# Wisconsin Department of Transportation

**Proposal #15: 1100-45-70, WISC2023222**  
**IH 41 Airport Freeway**  
**84th Street to 35th Street (Mainline)**  
**IH 41**  
**Milwaukee County**

**1100-46-71, WISC2023223**  
**IH 41 Airport Freeway**  
**STH 36 (Loomis Rd) Bridge**  
**IH 41**  
**Milwaukee County**

This is Addendum No. 01, which provides for the following:

Addendum No. 01  
ID 1100-45-70  
Added Sheet 79A  
February 8, 2023

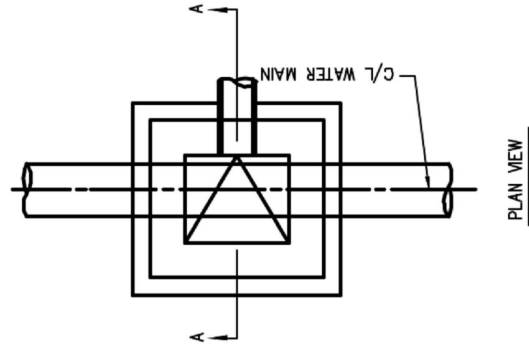
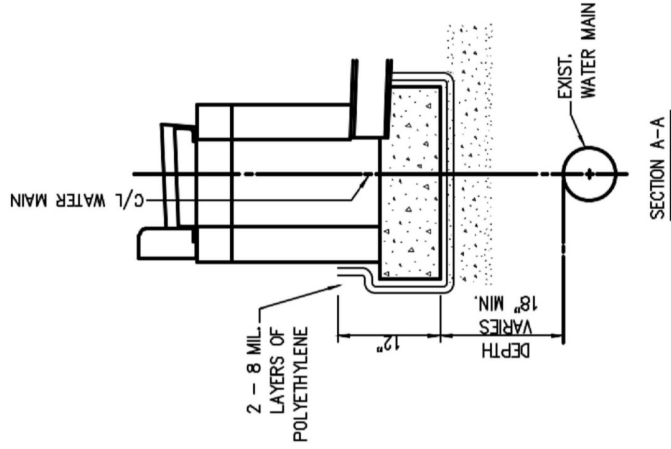
<b>Added Plan Sheets – 1100-45-70</b>	
Plan Sheet	Plan Sheet Title (brief description of why sheet was added)
79A	Construction Detail – Water Main Protection (Required for storm sewer construction near water mains)
304A-304G	Traffic Control – Nighttime Closure Details (Required for freeway nighttime closures)
335A-335B	Detour – IH 43 NB Ramp (Required for freeway nighttime closures) Detour – Ramp NW (Required for freeway nighttime closures)
625A	SDD Traffic Control, System Ramp Closure (Required for freeway nighttime closures)

**WATER MAIN PROTECTION**  
INSTALL ON ALL CATCH BASINS OR INLETS WITH  
LESS THAN 24" HORIZONTAL OUT-TO-OUT  
CLEARANCE FROM STRUCTURE TO WATER MAIN

Addendum No. 01  
 ID 1100-45-70  
 Added Sheet 304A  
 February 8, 2023

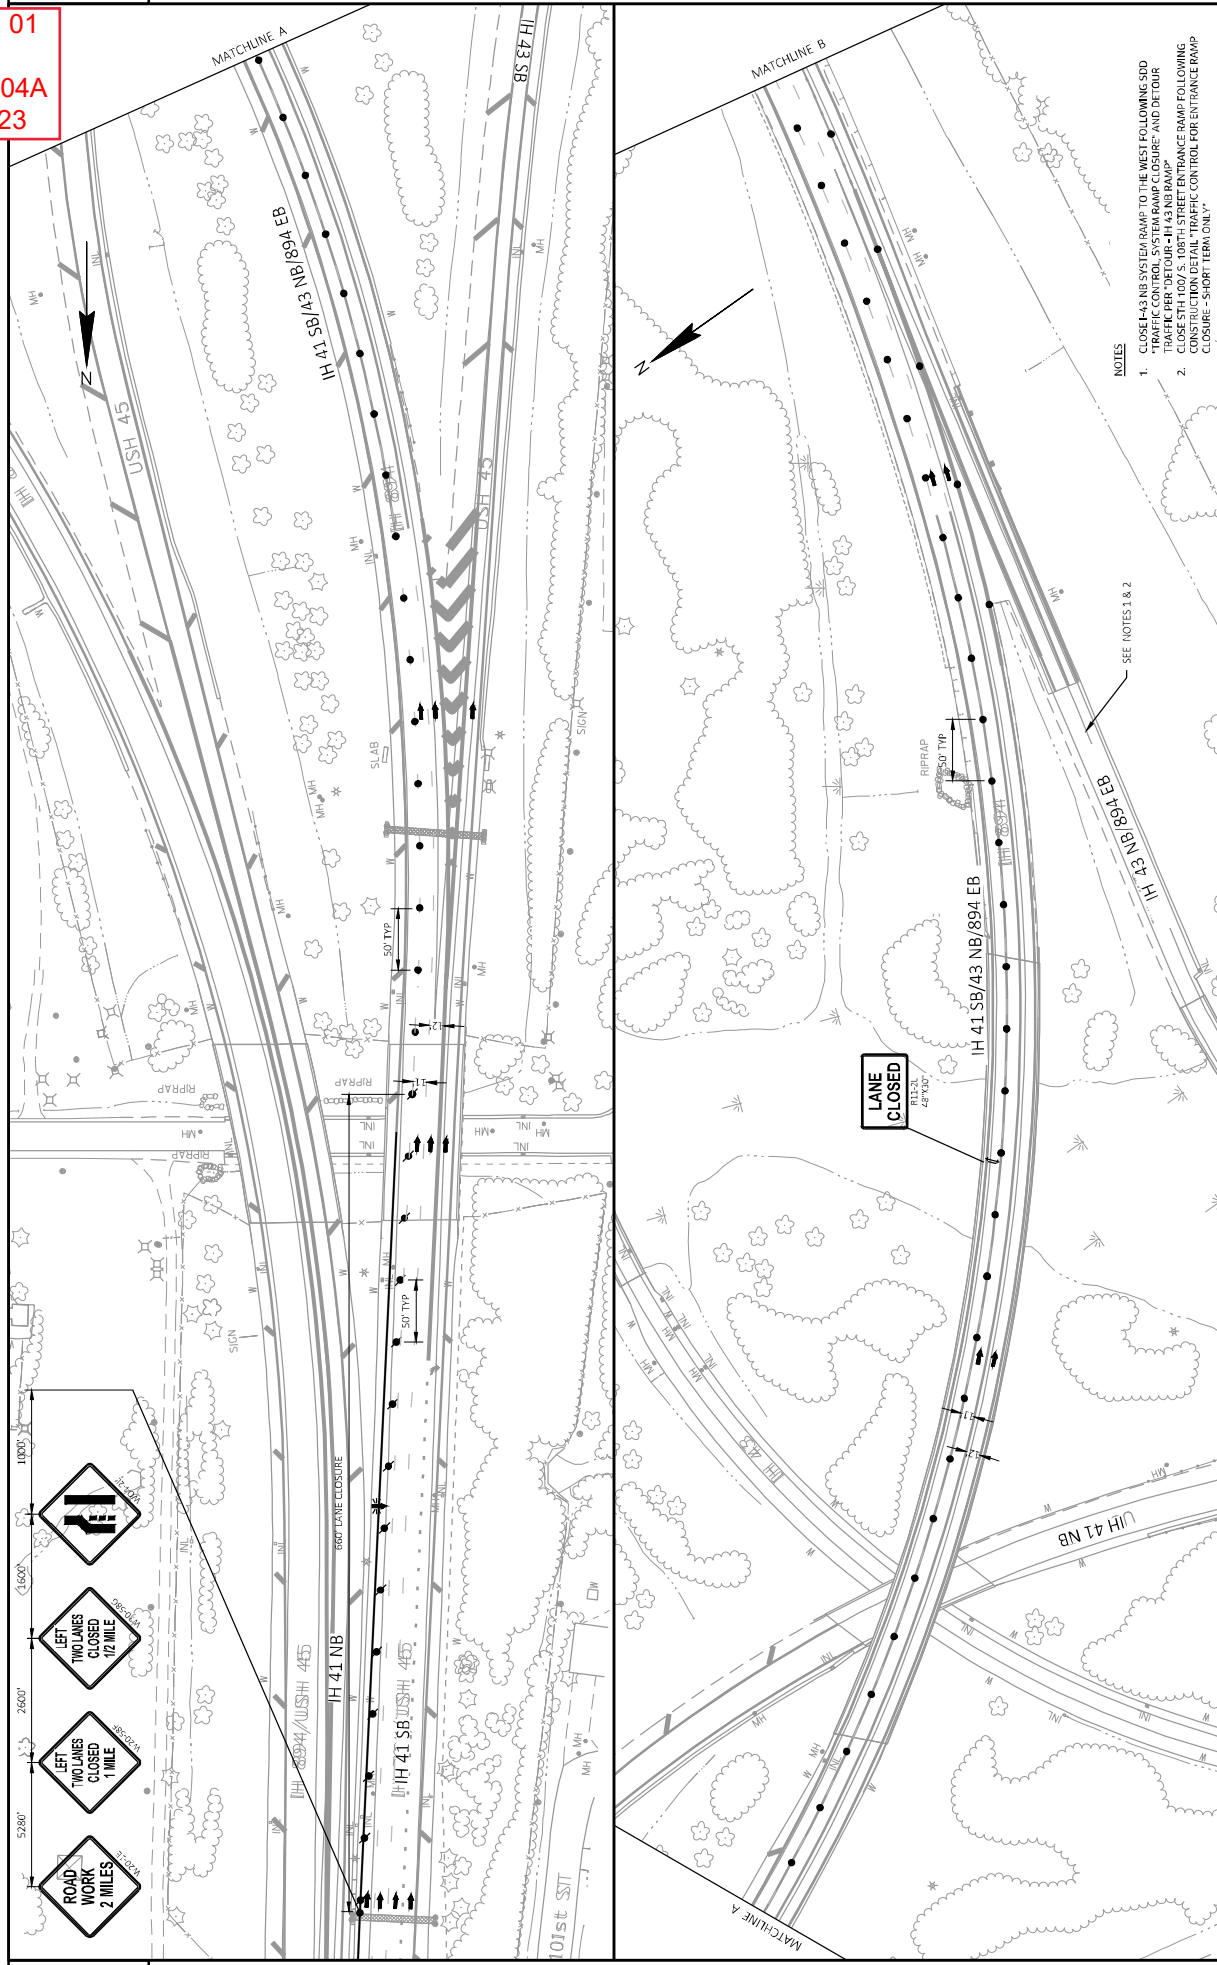
1. CLOSE I-43 BUS SYSTEM RAMP TO THE WEST FOLLOWING SDD TRAFFIC CONTROL SYSTEM RAMP CLOSURE AND DETOUR TRAFFIC PER DETOUR - IH 43 NB RAMP
2. CLOSE 5TH 1007.5 - 108TH STREET ENTRANCE RAMP FOLLOWING CONSTRUCTION DETAIL TRAFFIC CONTROL FOR ENTRANCE RAMP CLOSURE - SHORT TERM ONLY

Addendum No. 01  
ID 1100-45-70  
Added Sheet 625A  
February 8, 2023

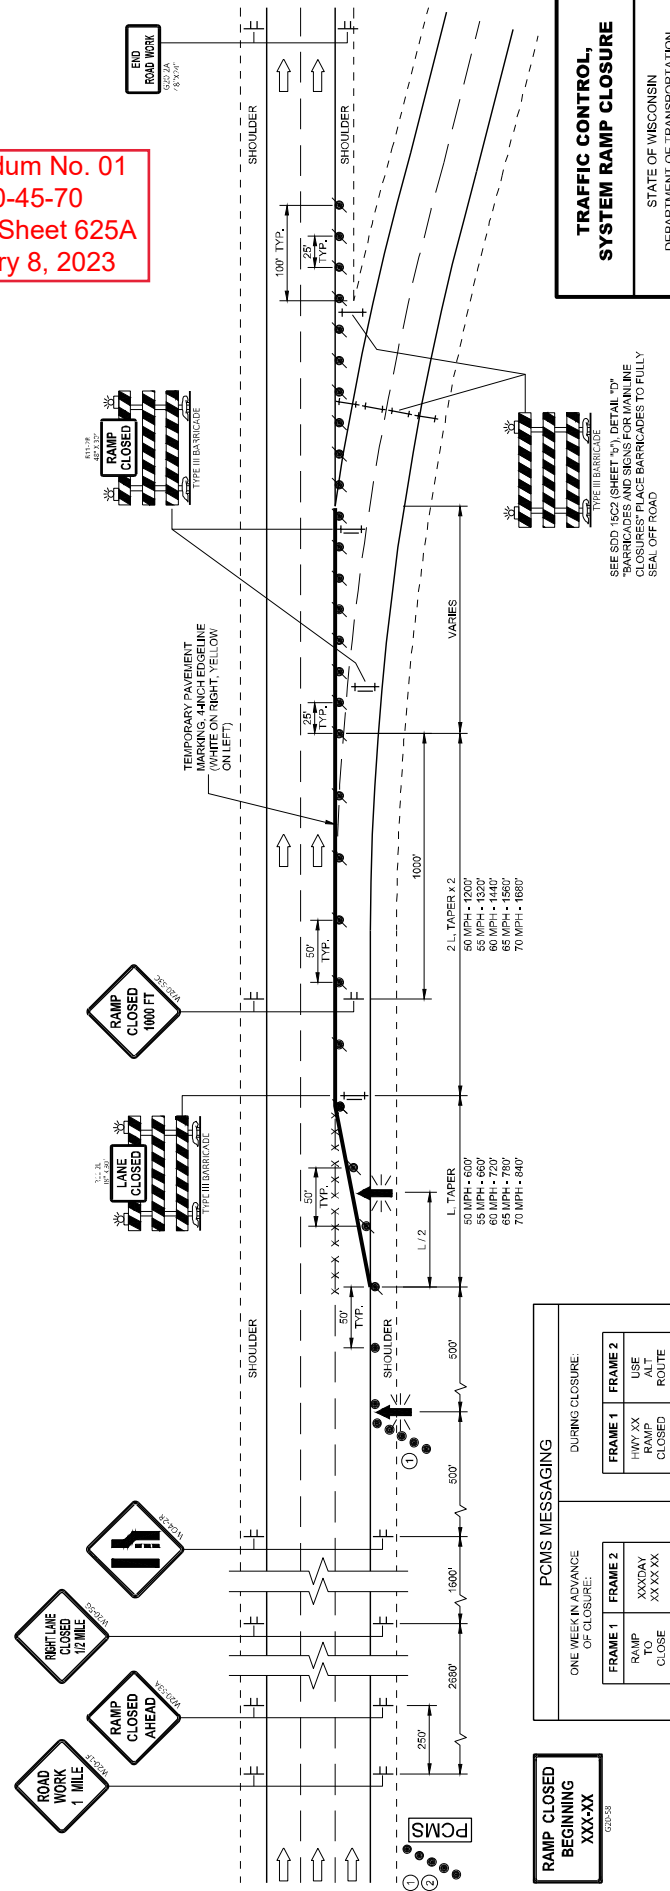
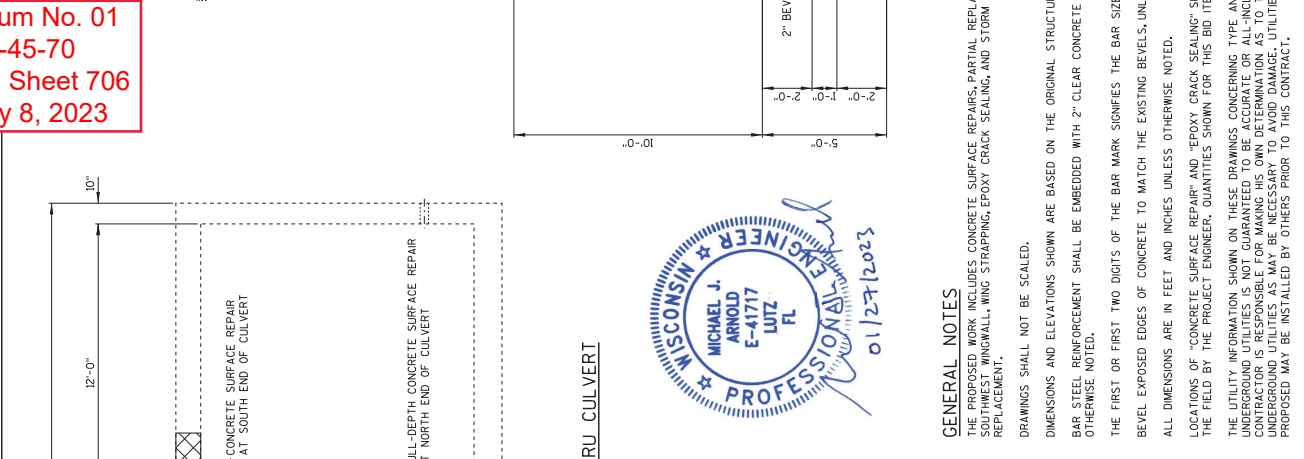
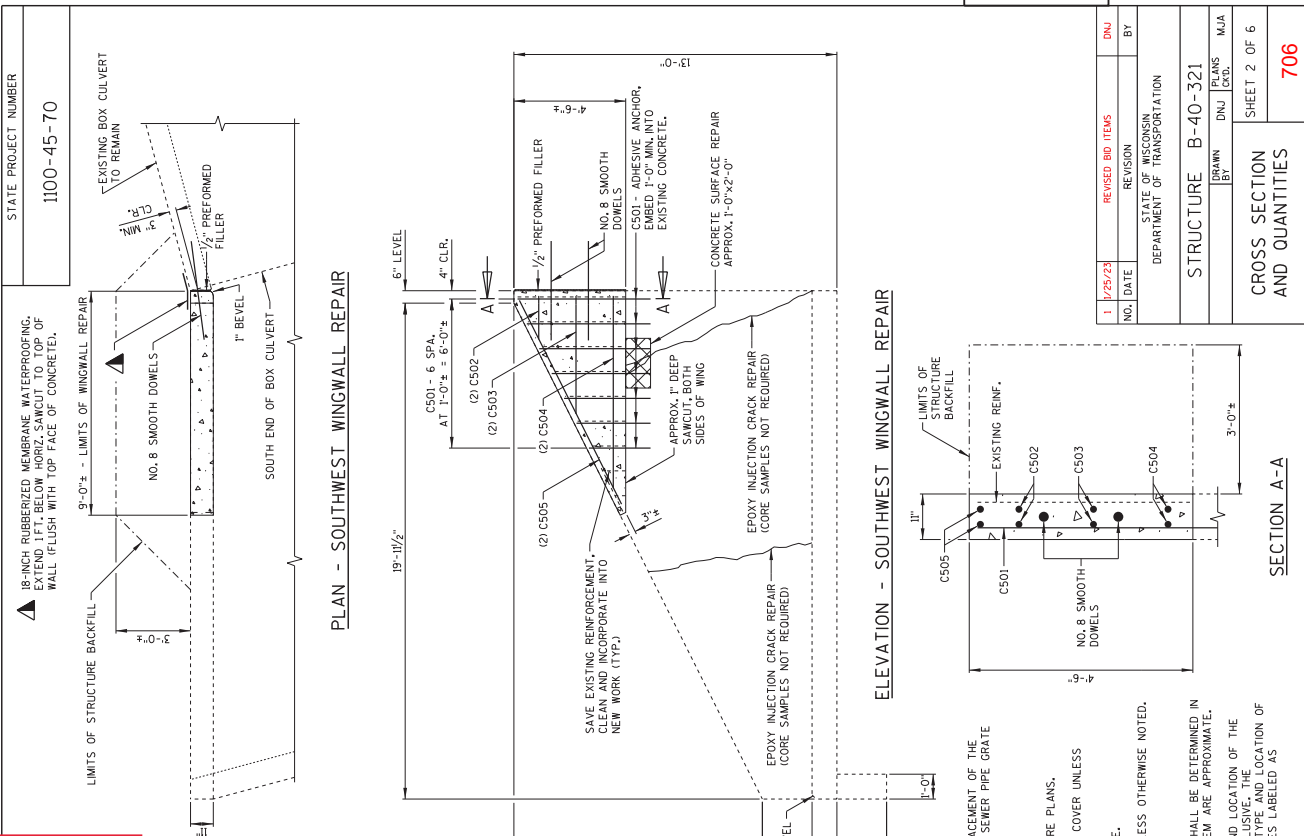
Added Special Provisions	
Article No.	Description
178	Pipe Grates, 42-Inch, Item 611.9800.S.001; Pipe Grates, 84-Inch, Item 611.9800.S.002
179	Traffic Control Close-Open Freeway to Freeway System Ramp, Item SPV.0060.032
180	Sanitary Manhole Internal/External Seal, Item SPV.0060.503

Install or reposition traffic control devices required for closing a freeway system ramp and adjacent auxiliary lanes. Remove or return traffic control devices to their previous configuration when the closure is no longer required.

Addendum No. 01  
ID 1100-45-70  
Revised Sheet 706  
February 8, 2023

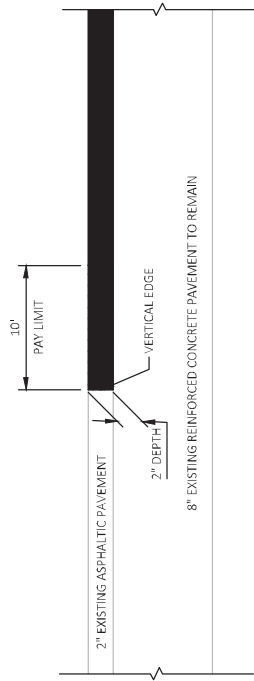
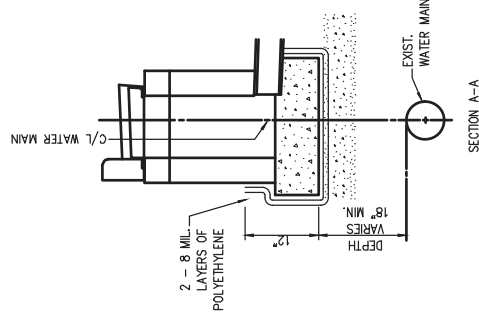
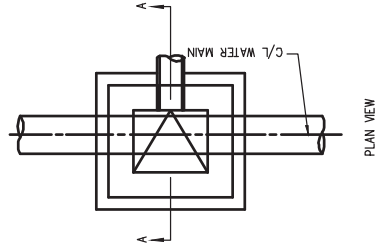
<b>Revised Plan Sheets – ID 1100-45-70</b>	
Plan Sheet	Plan Sheet Title (brief description of changes to sheet)
385	Miscellaneous Quantities (Added Water Main Protection item quantities)
436-444	Miscellaneous Quantities – Lighting (Revised quantities)
474-477	Miscellaneous Quantities – Traffic Control (Added Traffic Control Close-Open Freeway to Freeway System Ramp item quantities, added IH 41 NB Ramp and Ramp NW Detour quantities, and revised traffic control quantities)
539	SDD Concrete Barrier Temporary Precast, 12'-6" (Added specific information about drilling pilot holes)
706	Structure B-40-321 Cross Section and Quantities (Revised quantities)

Addendum No. 01  
 ID 1100-46-71  
 Revised Sheet 15  
 February 8, 2023

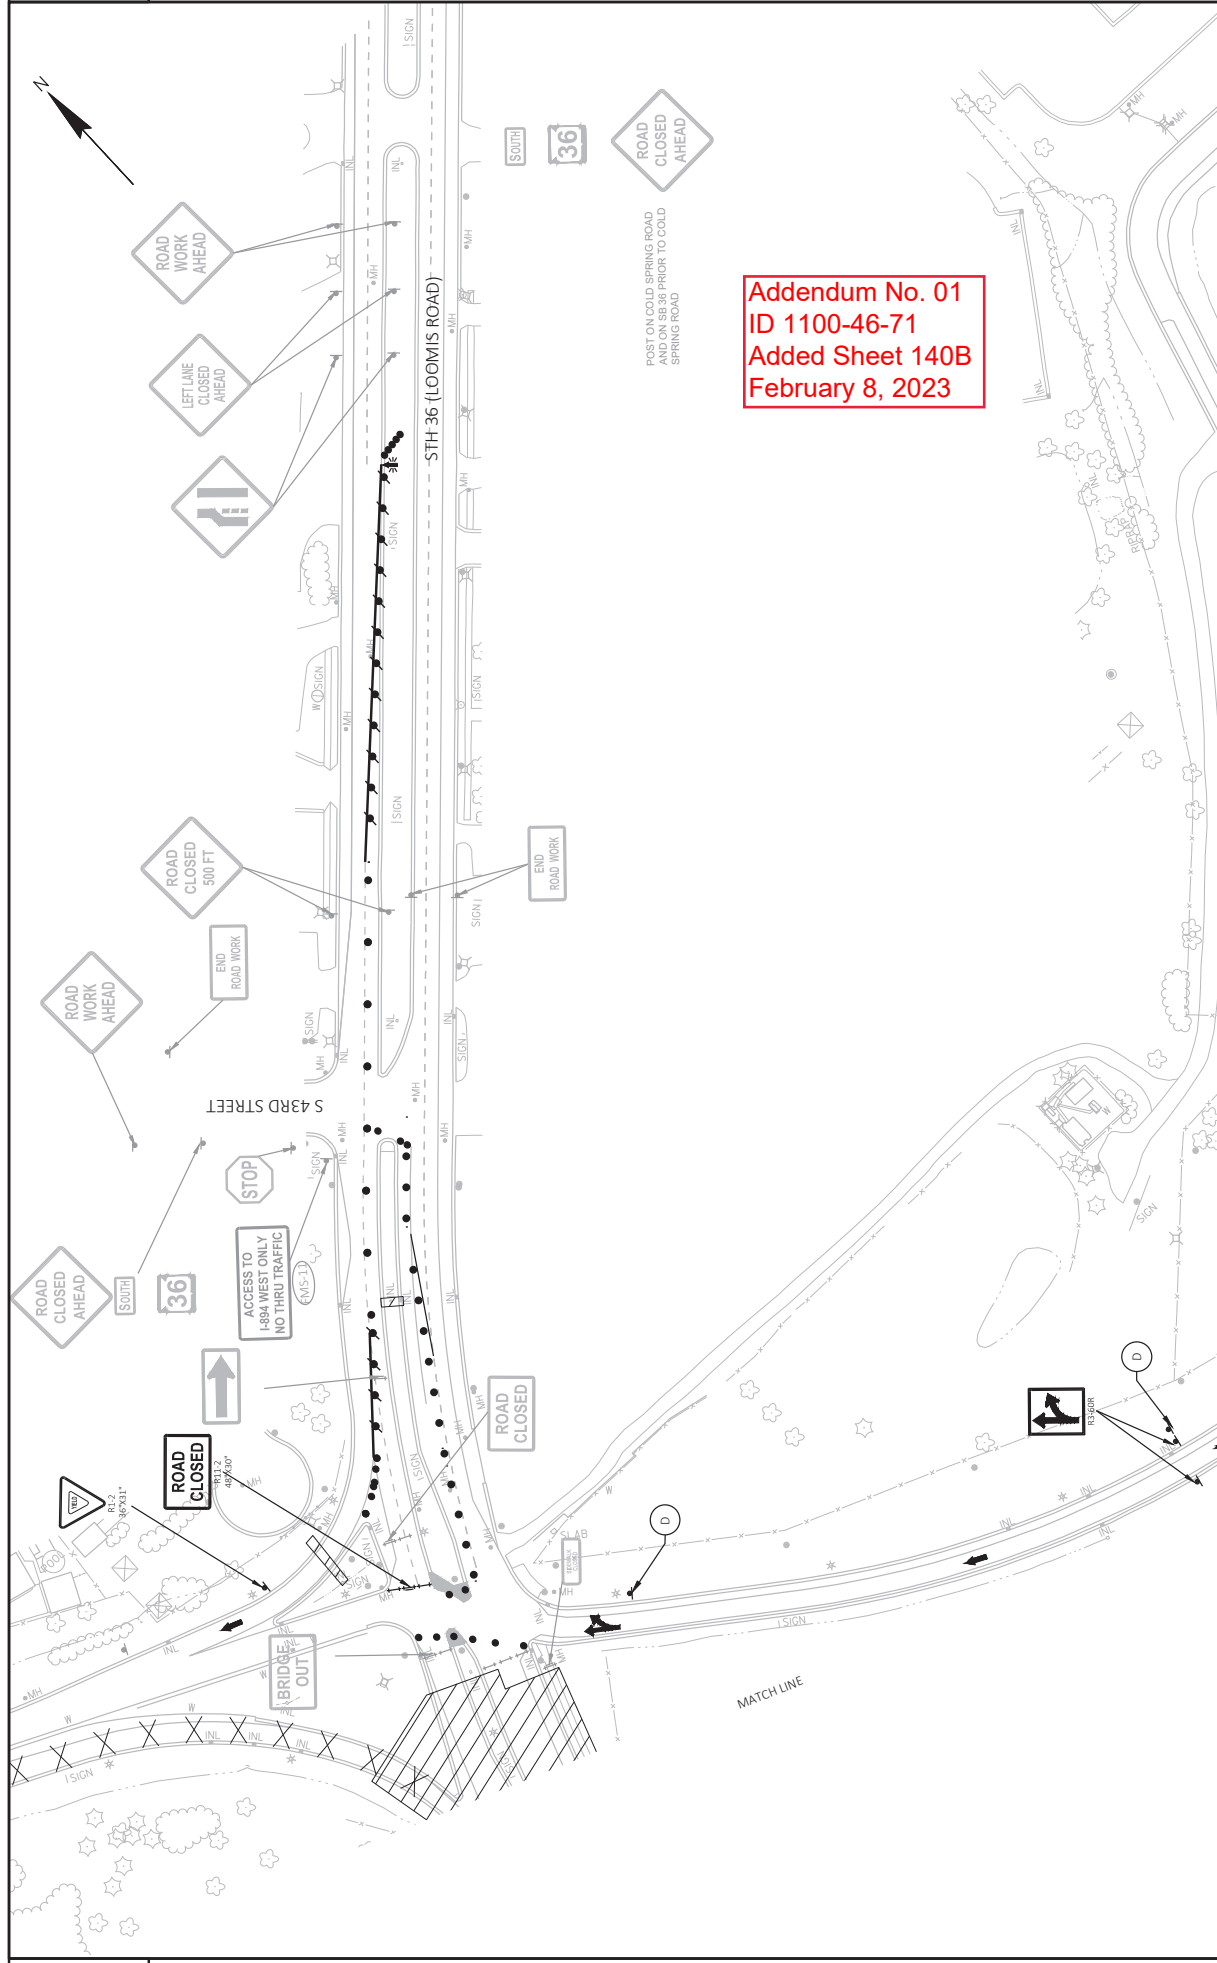
<b>Revised Plan Sheets – ID 1100-46-71</b>	
Plan Sheet	Plan Sheet Title (brief description of changes to sheet)
15	Construction Details (Updated Project Number)
